**Our Case Number: ABP-316828-23**

**Re:** Tallaght/Clondalkin to City Centre BusConnect Core Bus Corridor Scheme.  
Tallaght/Clondalkin to Dublin City.

# South Dublin County Council Submission on Bus Connects

Tallaght/Clondalkin to City Centre Core Bus  
Corridor Scheme.

Figure 9

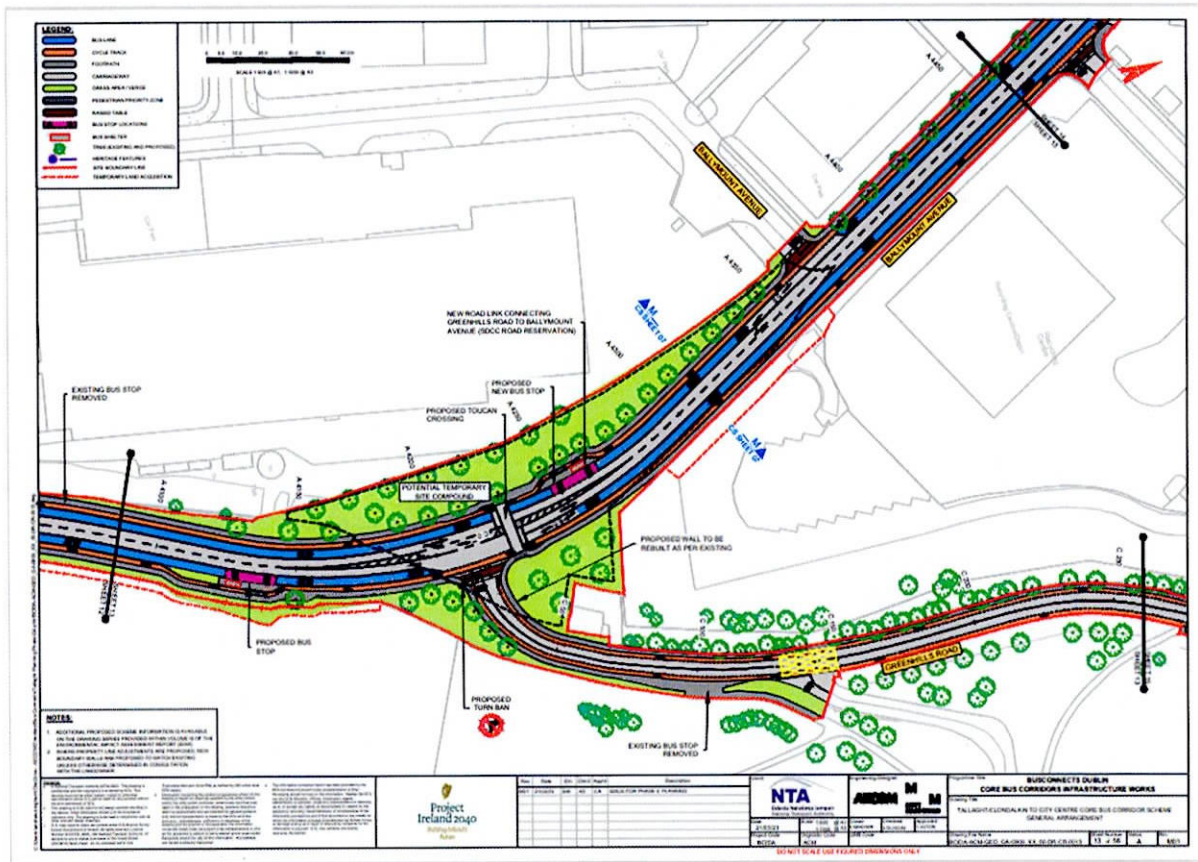
Protection of the extensive swathe of trees along Greenhills Road and minimising of tree removal is encouraged. The opportunity to provide more street trees should be taken.

Scope for reduction in land-take into Tymons Park by re-examining the sweep and width of the carriageway.

Figure 10

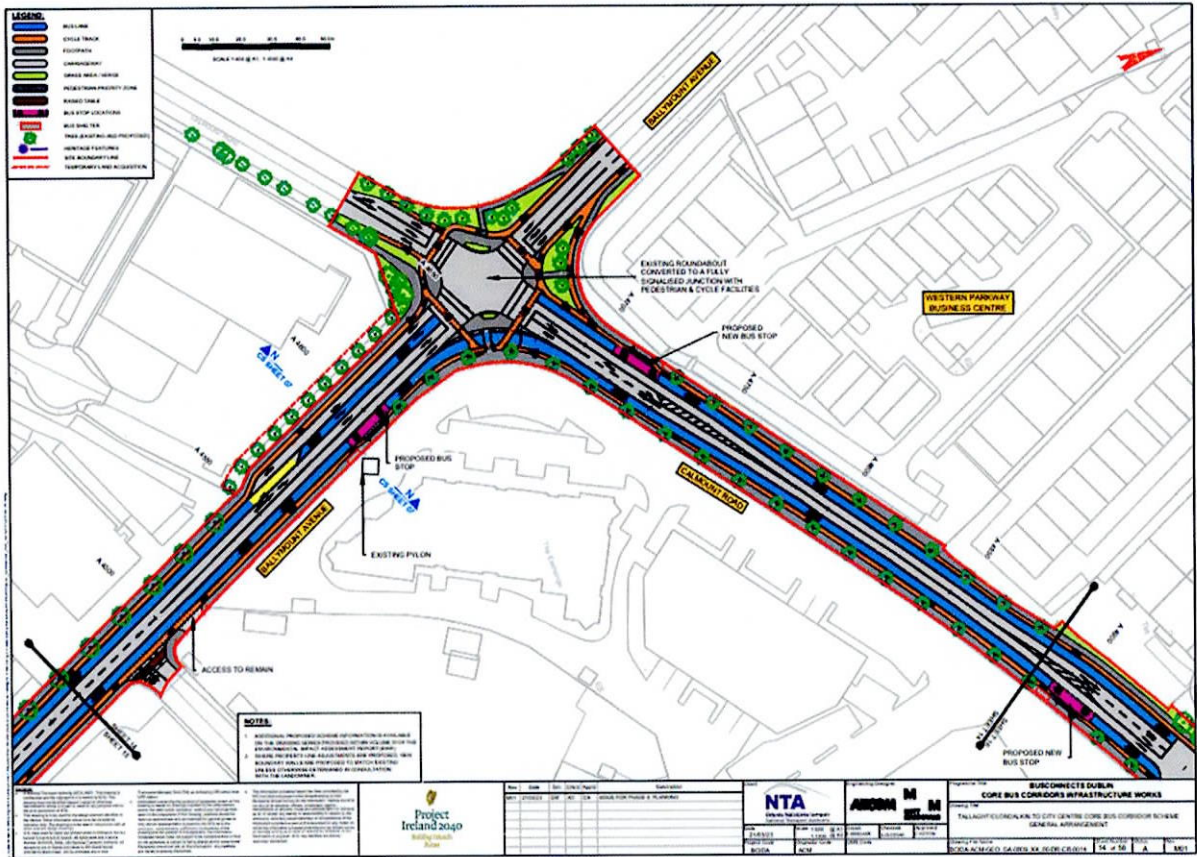
The opportunity for greening should be explored along the eastern side of Ballymount Road.
